Addendum #2

Date	Owner Property Number	Owner Building Number	BHDA Project Number
Fri, 22 Jun 2018	505-1975	Orem UT South FM Group Building #20	1822

Project Designation	Project Address
Cherry Hill 1, 2, 4 Mother's Room Orem UT Cherry Hill Stake	1700 South 400 East Orem, Utah 84058

SHEET TITLE:
SOUND SYSTEM PLANS

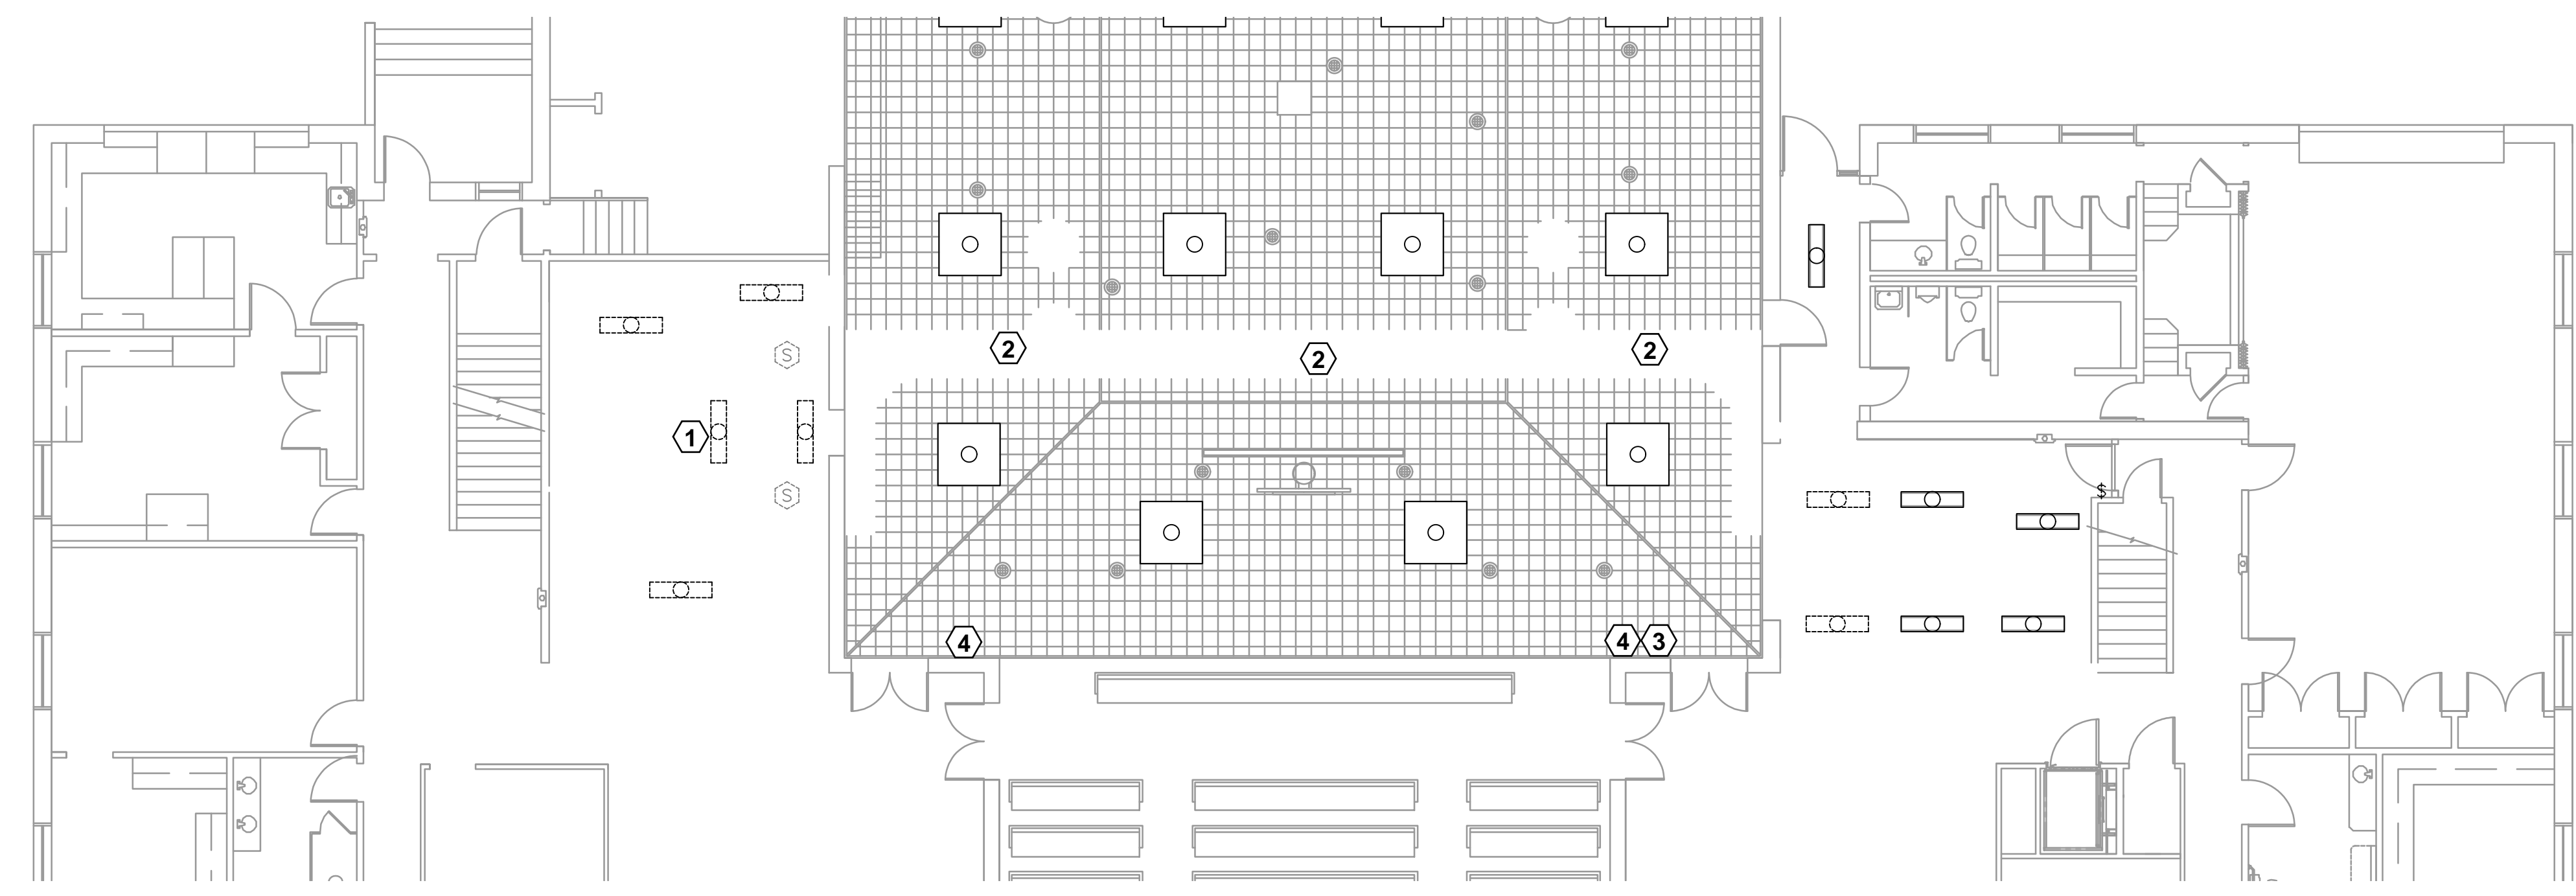
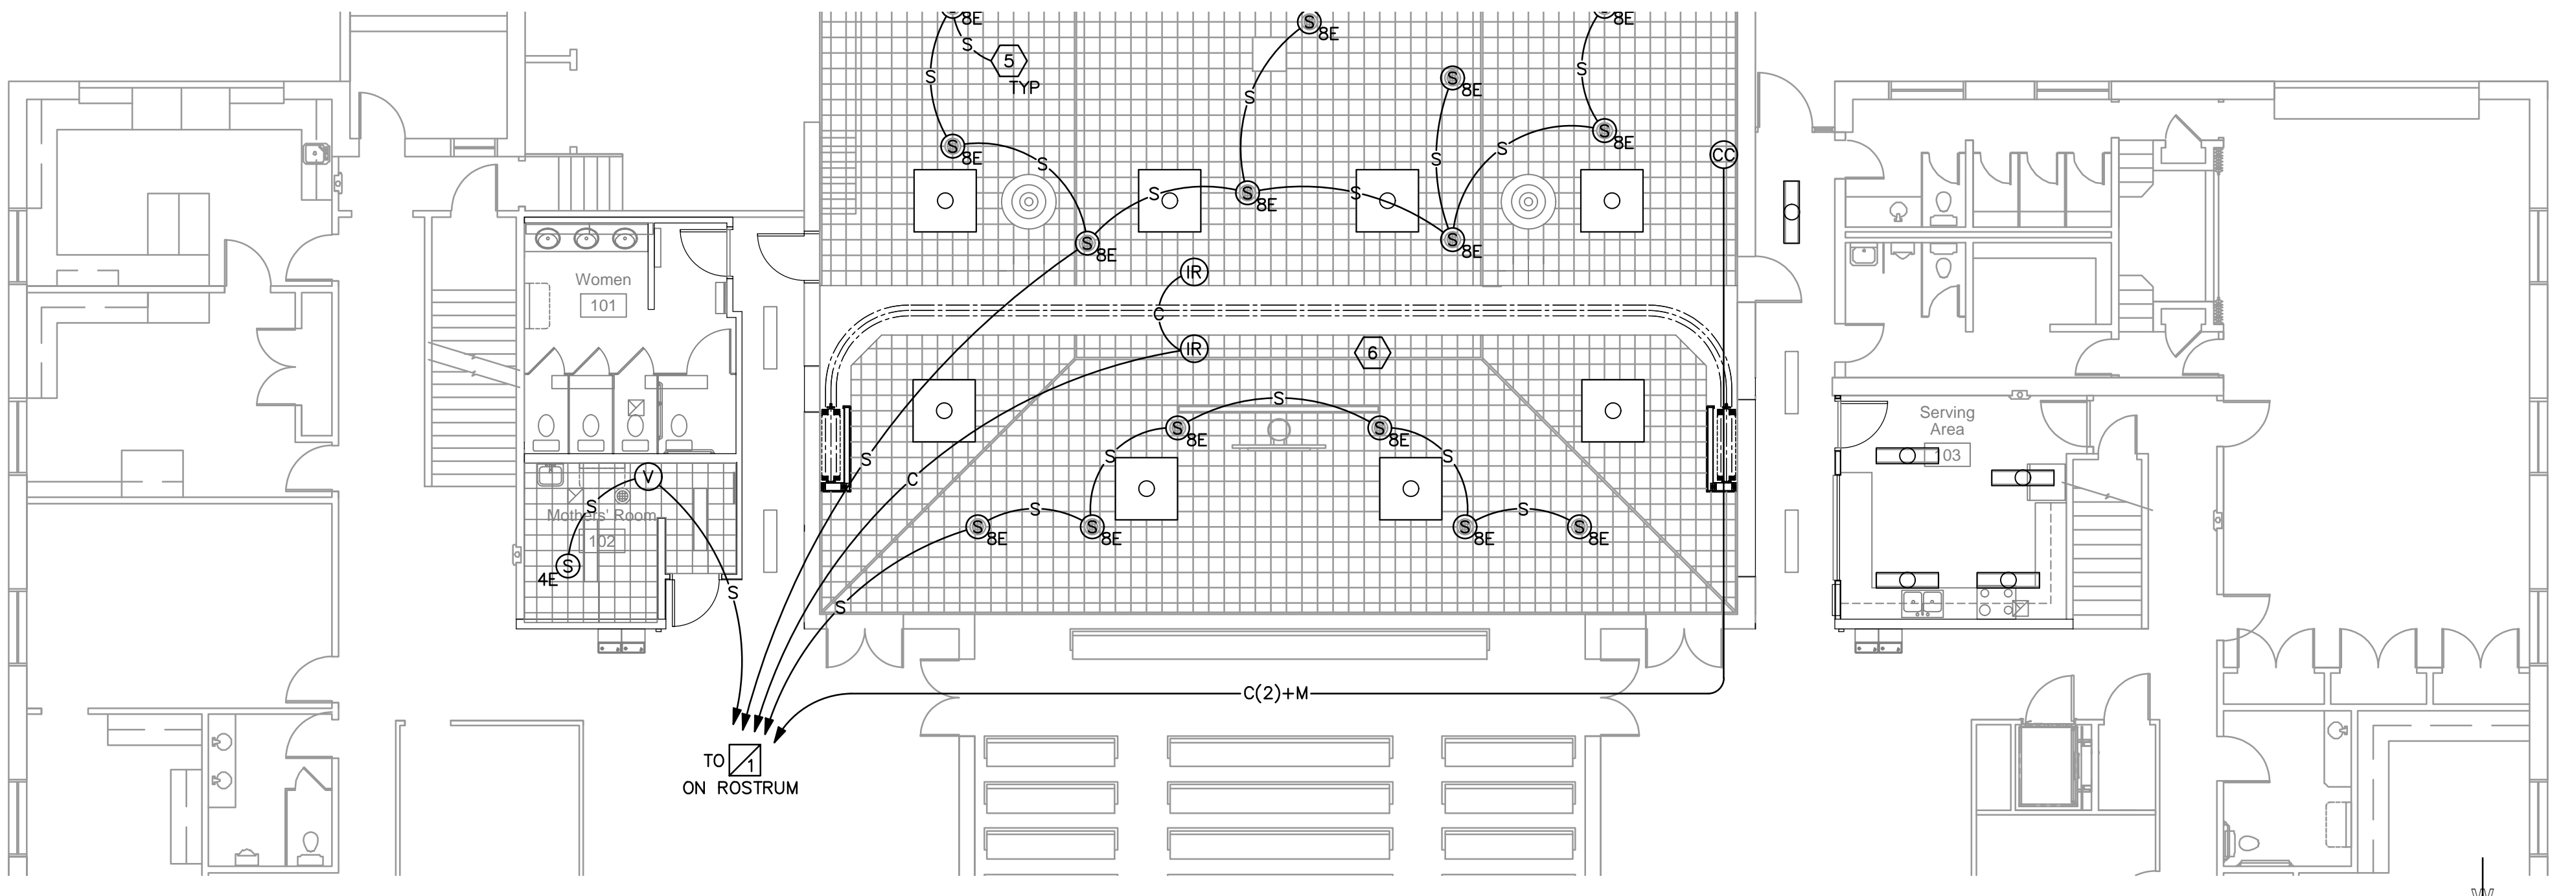
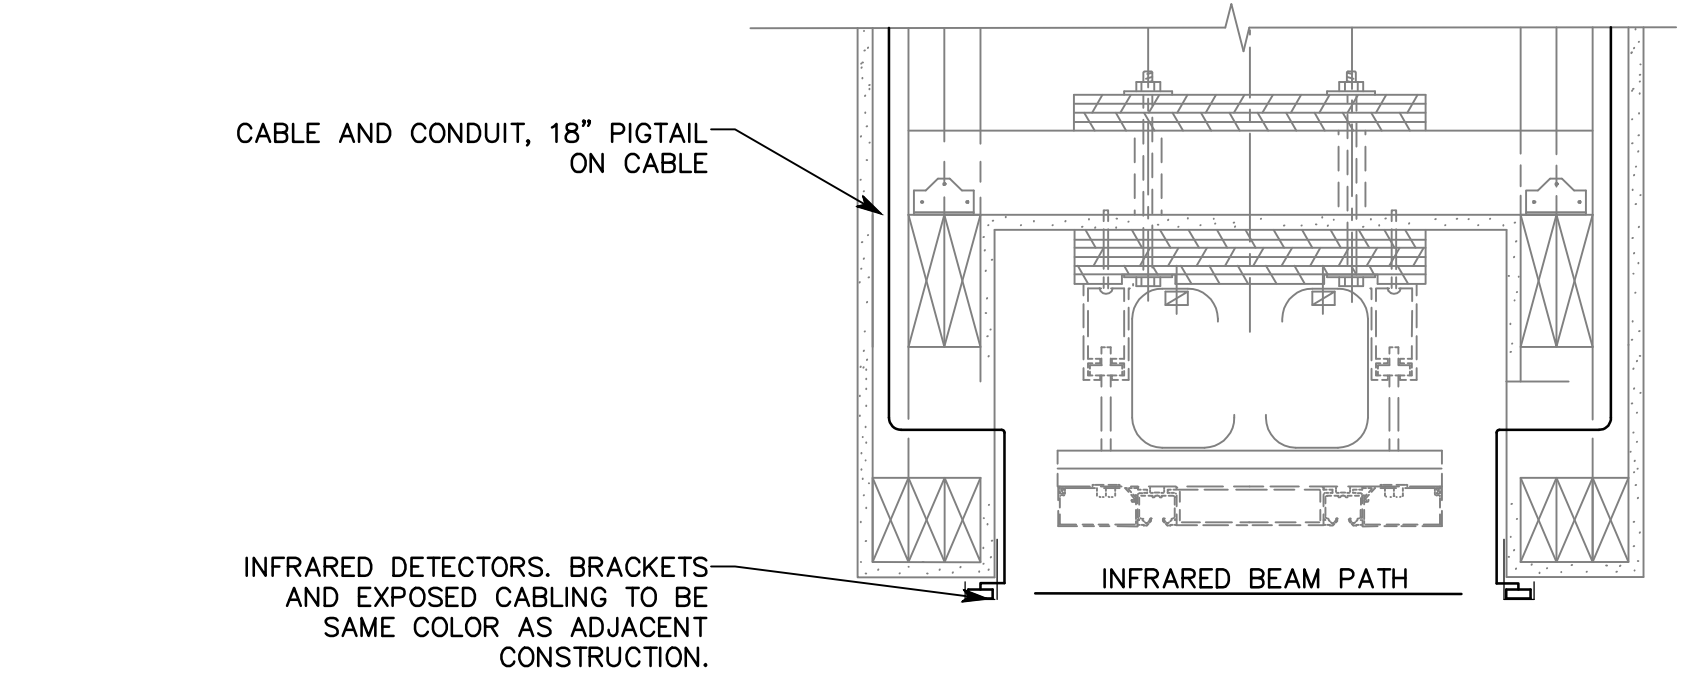
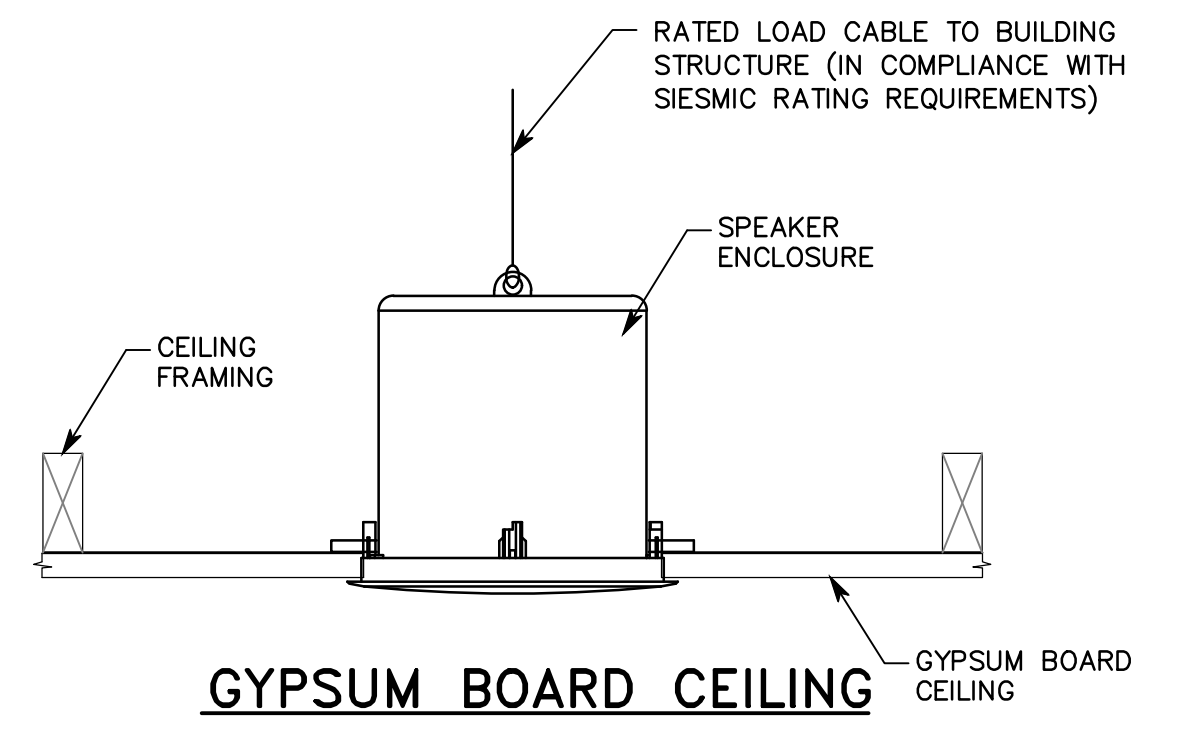
4.05. Sheet E112 Sound System Plans

- A. Add this Sheet to the Bid Documents.
- B. Instruction for how to modify the AV system to accommodate the new accordion folding partition.

SHEET TITLE:
SOUND SYSTEM SCHEDULE, NOTES, DETAIL AND DIAGRAM

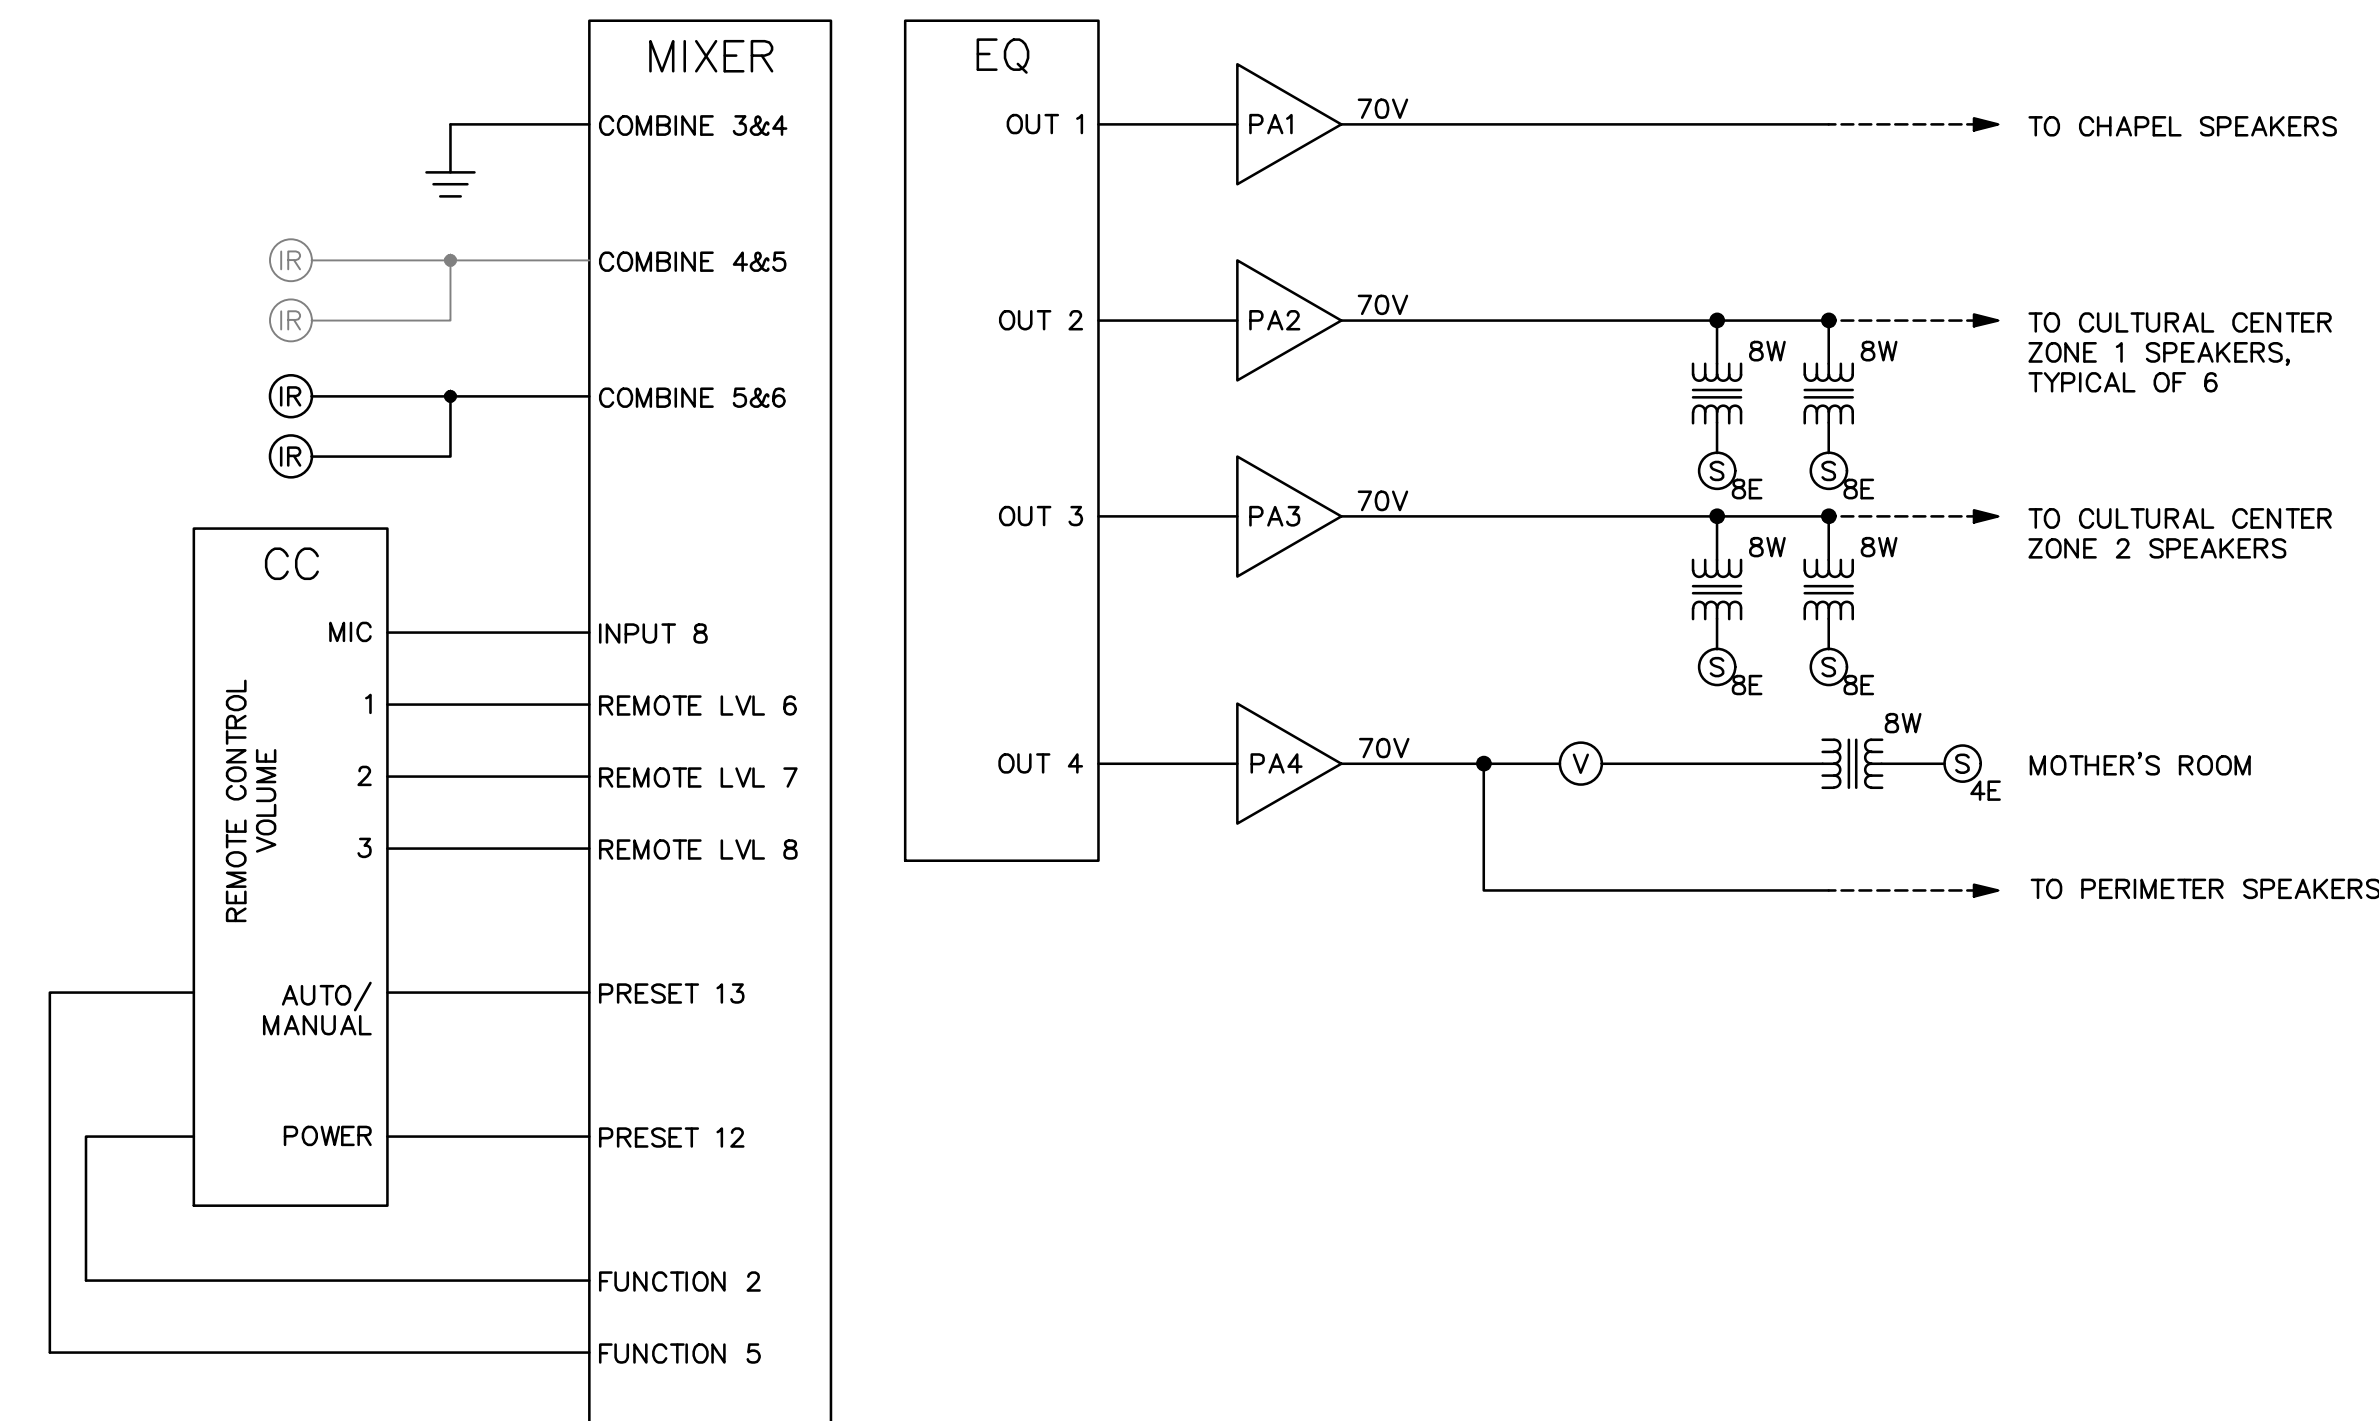
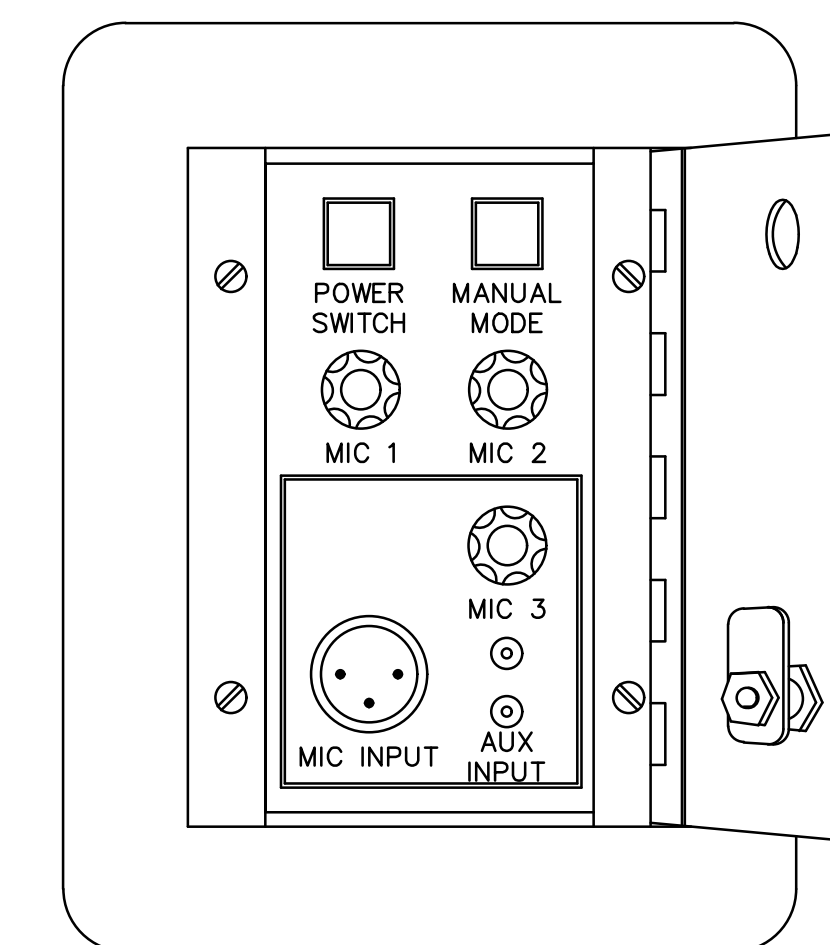
4.06. Sheet T601 Sound System Schedule, Notes, Detail and Diagram

- A. Add this Sheet to the Bid Documents.
- B. Instruction for how to modify the AV system to accommodate the new accordion folding partition.
